DISTRIBUTION CODE MODIFICATION PROPOSAL FORM

Modification Proposal submitted By: ESB Networks	DATE OF SUBMISSION OF PROPOSAL: 5-5-15	Modification Proposal Number: <i>(to be assigned by Review Panel Secretary)</i> 42
--	--	--

MODIFICATION PROPOSAL TITLE:	Clarity of Power Factor requirements for windfarms at low power levels
-------------------------------------	--

- DCC 11.4.3
- Replacement of Figs 11 and 12

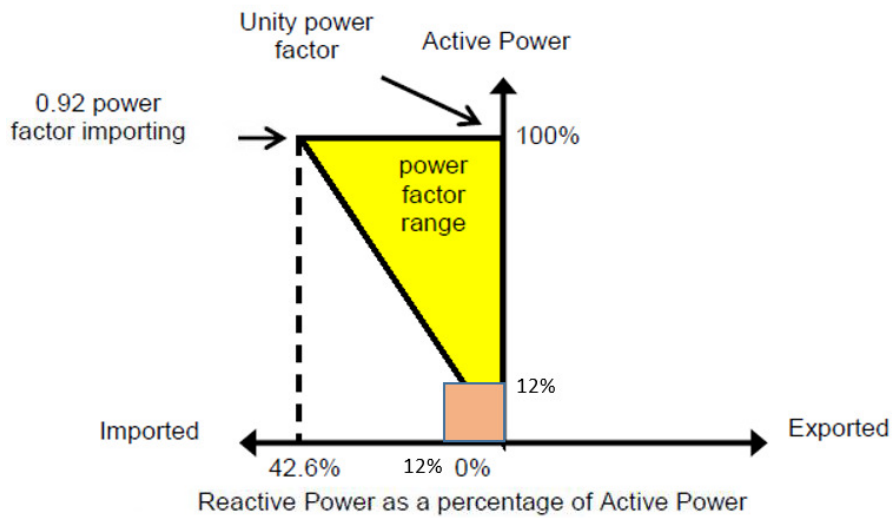
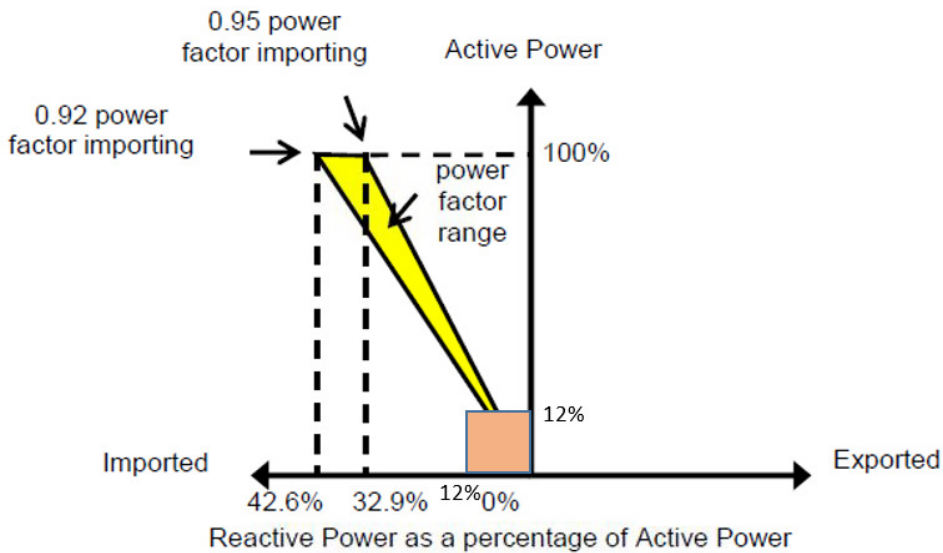
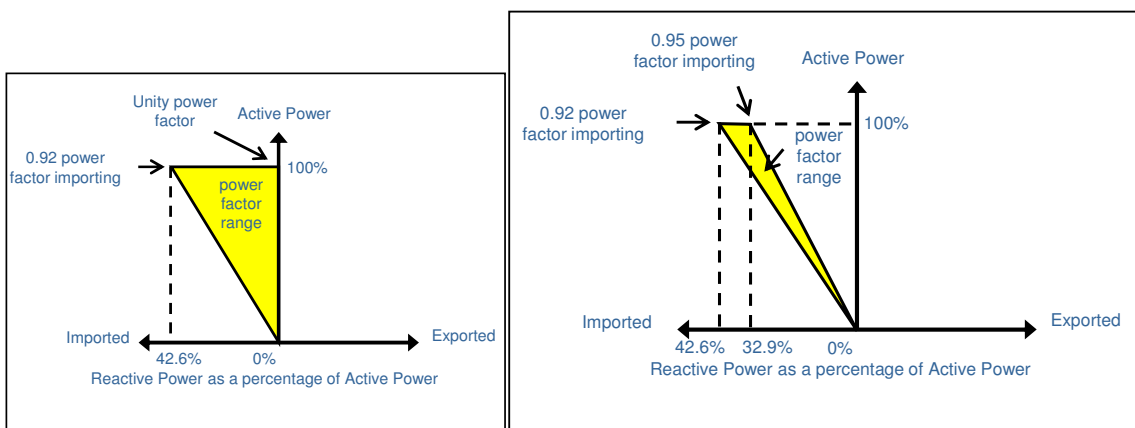
It is proposed to allow a region below 12% of Registered Capacity, within which the Reactive Power at the Connection Point can vary up to a maximum of 0.12 of - Q / P [importing Vars].

For avoidance of doubt, at power levels of less than 12% of Registered Capacity, the Reactive Power at the Connection Point can vary up to a maximum of 12% of – the Registered Capacity value, expressed in MVar [importing Vars].

Figures 11 and 12 to amended as shown below.

In the course of the development of Mod #35, the opportunity was taken to replace the previous Figure 11. This had been factually incorrect and not in agreement with the pre-mod text. It was replaced by two more explicit diagrams, which more accurately reflected both the pre and post mod text.

The new diagrams necessary show lines going through the origin, which means PF is maintained at all MW levels.

This was always the intent of text but diagrams have shown it explicitly. Since issue of V5, several representations have been made to the effect that the adherence to a given PF cannot be guaranteed at such low power levels.

Proposed text to be added to DCC11.4.3
